**TENDER 16-20**

**WATER TREATMENT BUILDING**

**ADDENDUM NO. 5**

October 7<sup>th</sup>, 2016

**1 SURGE PREVENTION TANK - PLAN**  
SCALE: 1:50

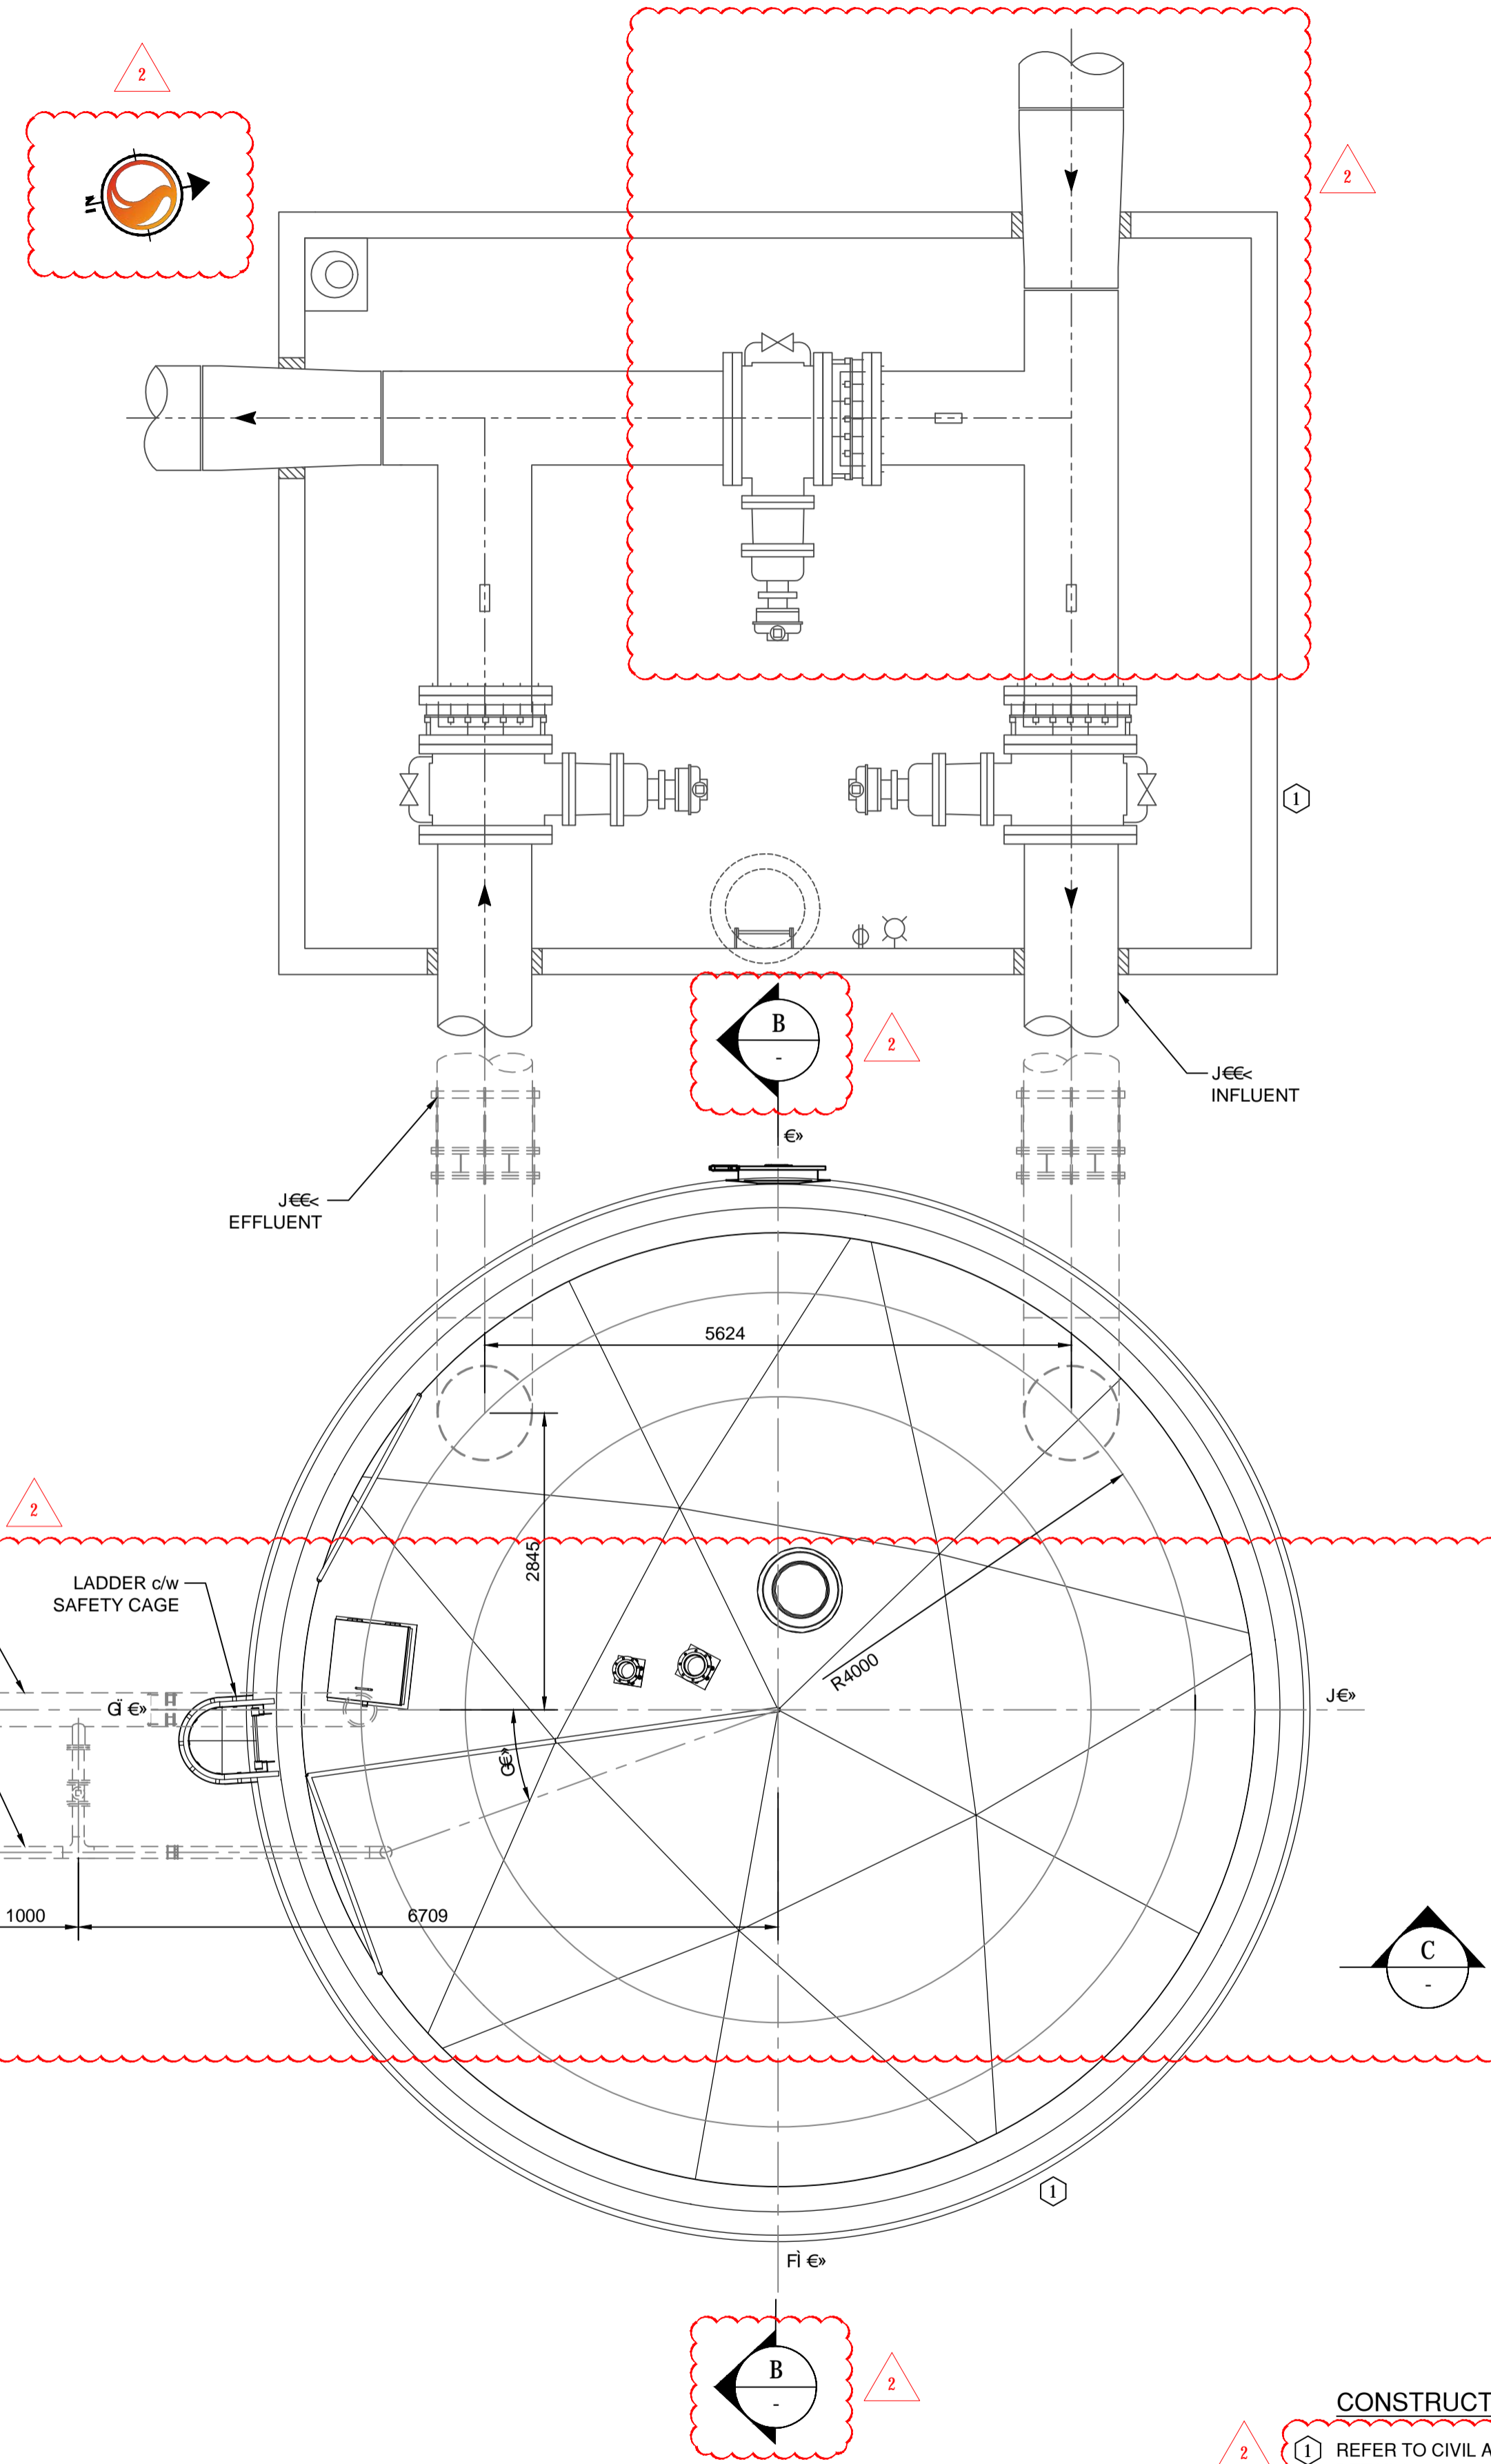
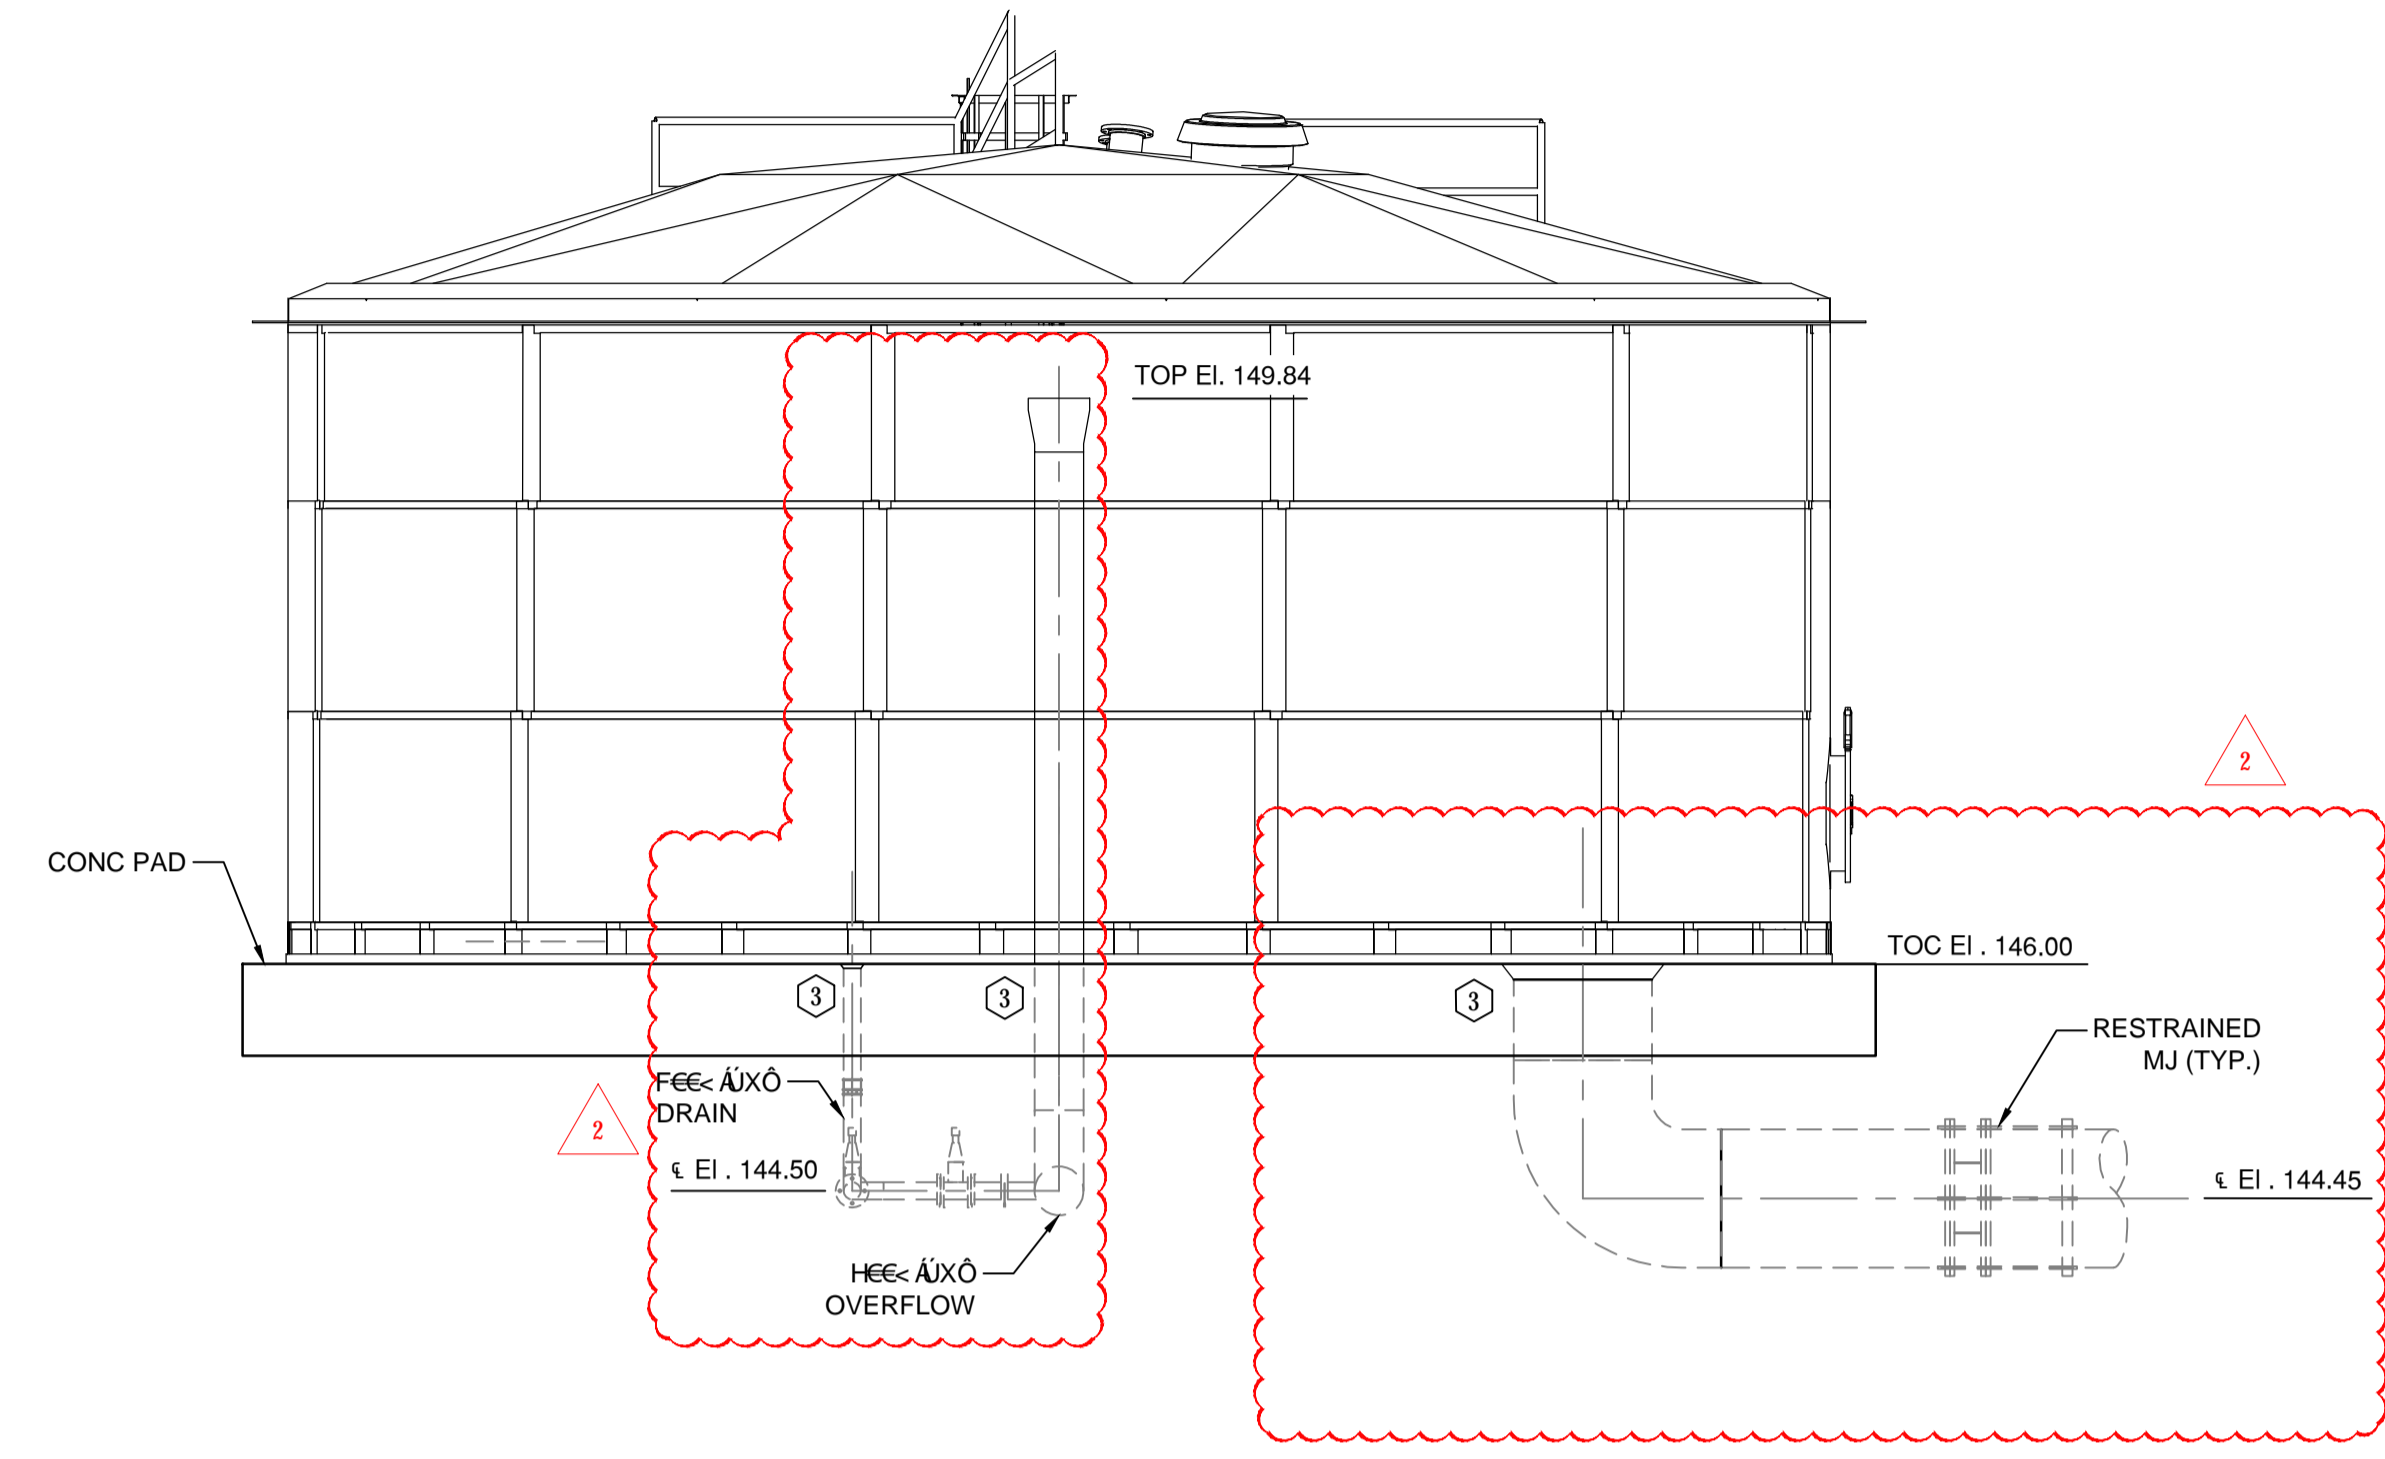
Please provide a civil drawing detailing the piping arrangement and material types for the surge prevention tank. The process piping drawings reference overflow and drain piping that does not appear on civil drawings.
